KEYSTONE XL PIPELINE PROJECT

| KEYSTONE XL PIPELINE PROJECT<br>PIPELINE ROUTE VARIATION FORM   |   |      |                           |

11 Assigned Tracking Number:  0258-SD-P4-350.7-351.5-I

*Proposed Route Variation 0258-01*

**RV-0258-01 - Looking Northwest at minute 06:11.671  
03/14/2012 CL (Blue line); Reroute (red line)**

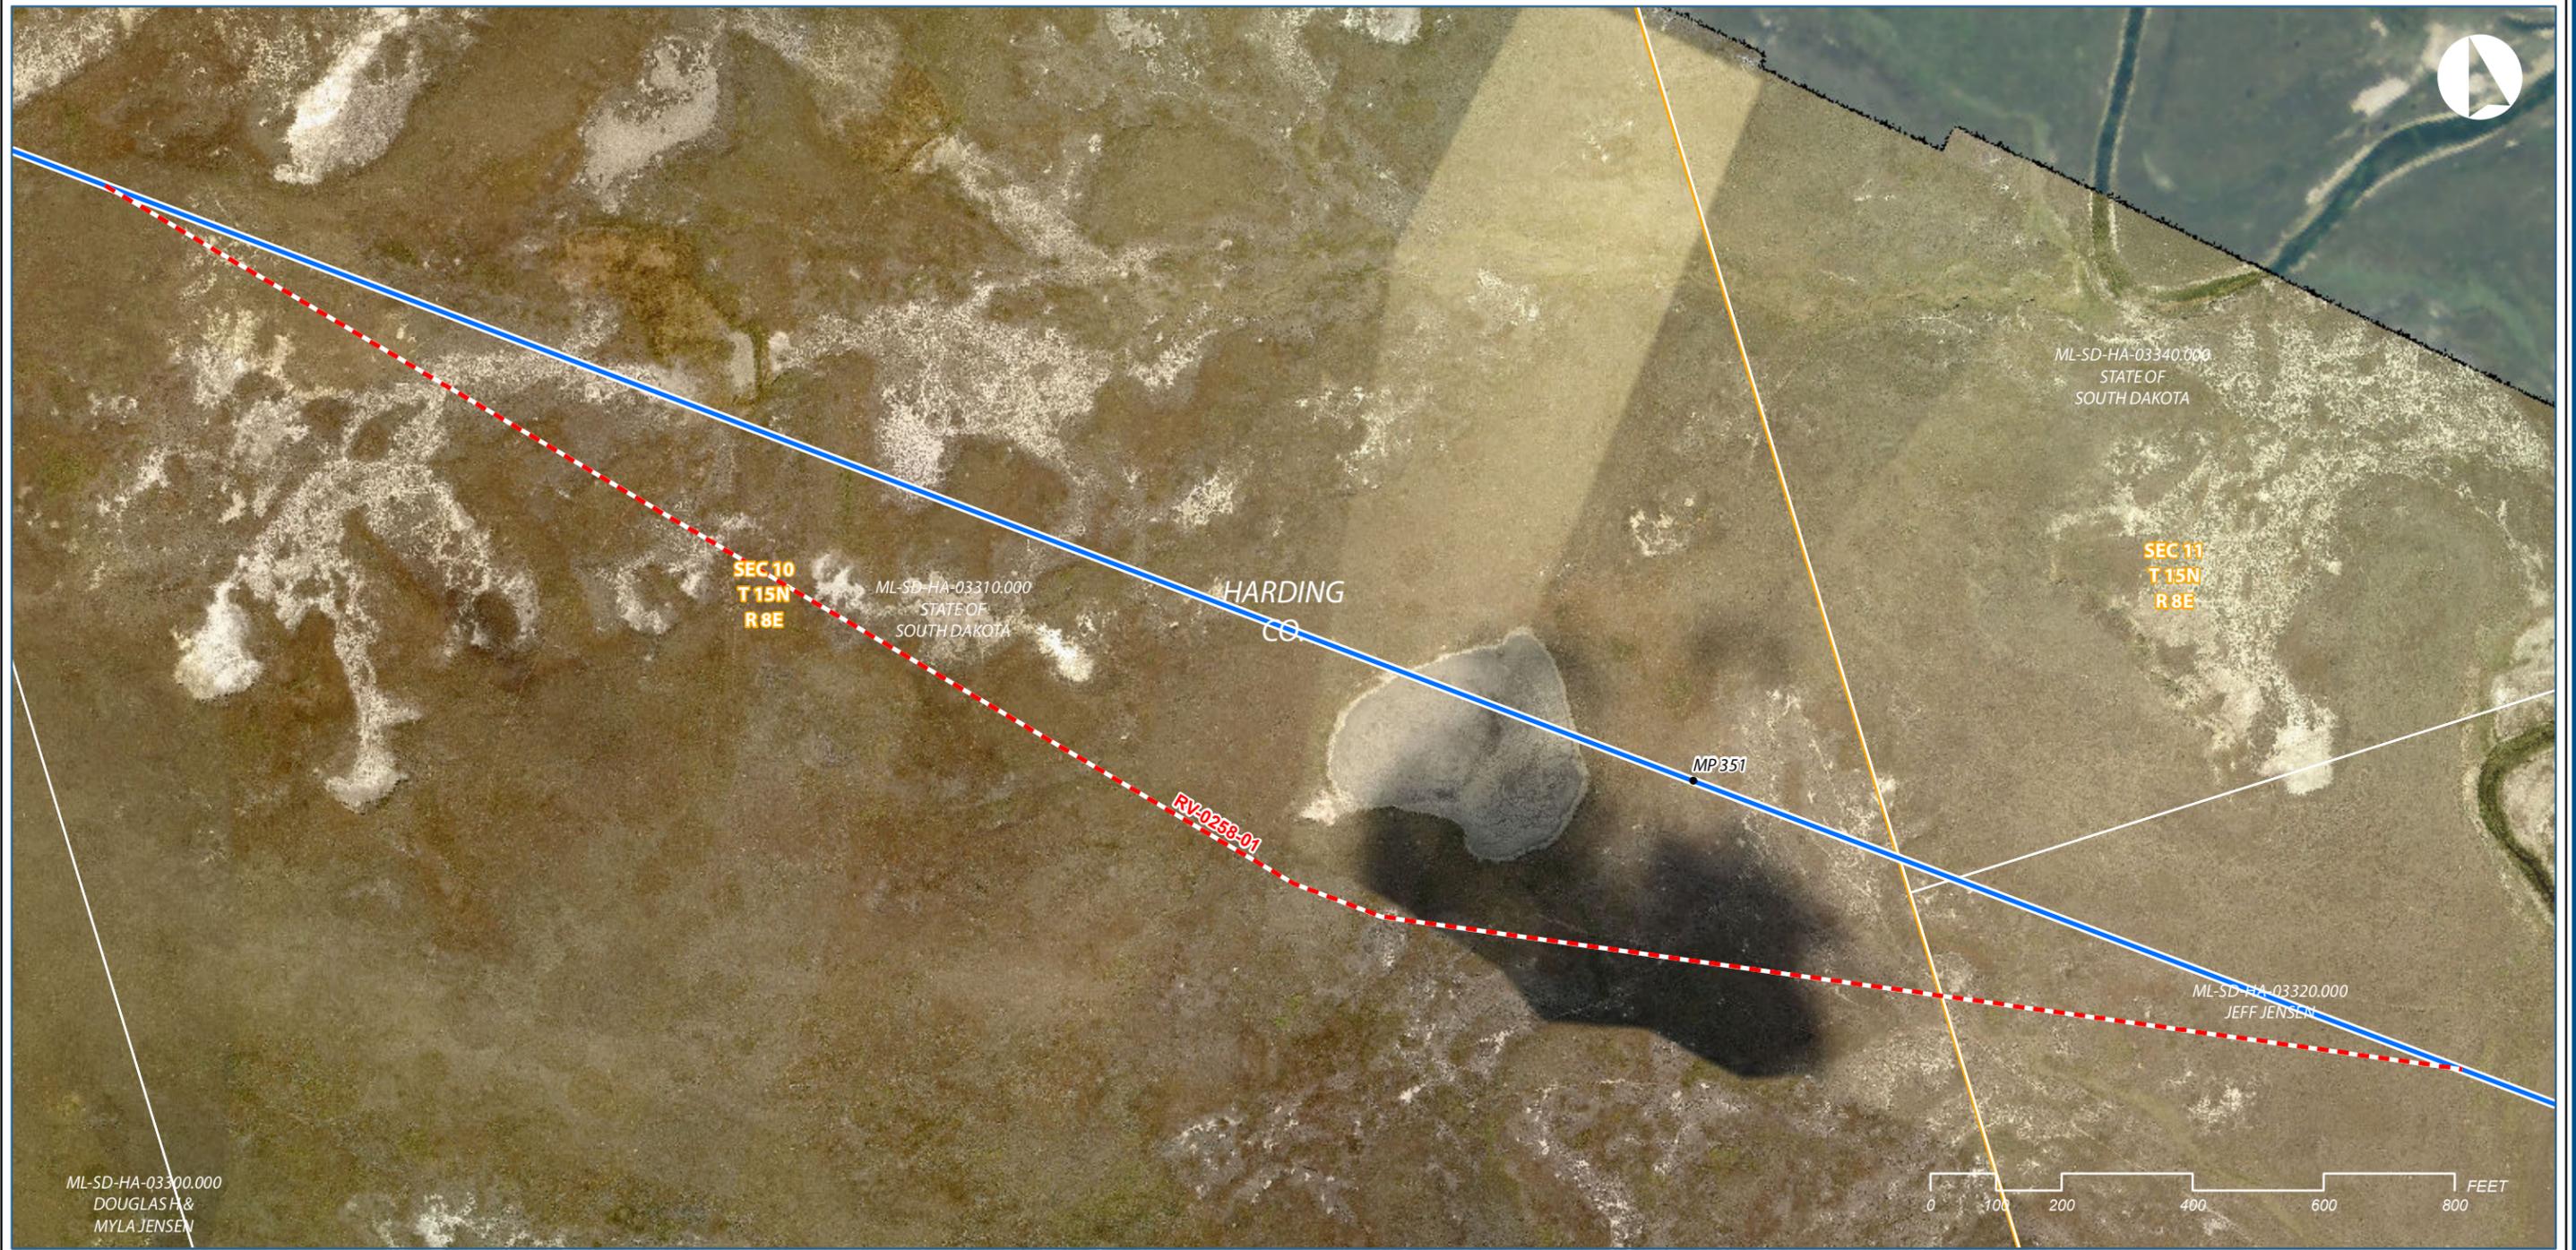
| KEYSTONE XL PIPELINE PROJECT<br>PIPELINE ROUTE VARIATION FORM   |   |      |                           |
|---|---|------|---------------------------|
| 3   | <b>REASON FOR ROUTE VARIATION</b> (Please include reason for route variation):<br><div style="border: 1px solid black; padding: 5px; min-height: 150px;"> <p>The primary reason for this reroute is to shift CL and workspaces out of and away from pond.</p> <p>The reroute has been proposed based on a combination of flyover video, LIDAR data, Pictometry and other aeriels.</p> </div>  |      |                           |
| <b>DETAIL ROUTE VARIATION</b> (Please describe route variation in detail):<br><div style="border: 1px solid black; padding: 5px; min-height: 150px;"> <p>Route variation starts near MP 350.7 and deviates ~10° southwest of CL. It continues in this direction for ~2,102 ft. This allows more distance (~160 ft.) between CL/workspaces and pond. Then the reroute turns east and extends for ~1,809 ft. before rejoining the C/L near MP 351.5.</p> </div> |   |      |                           |
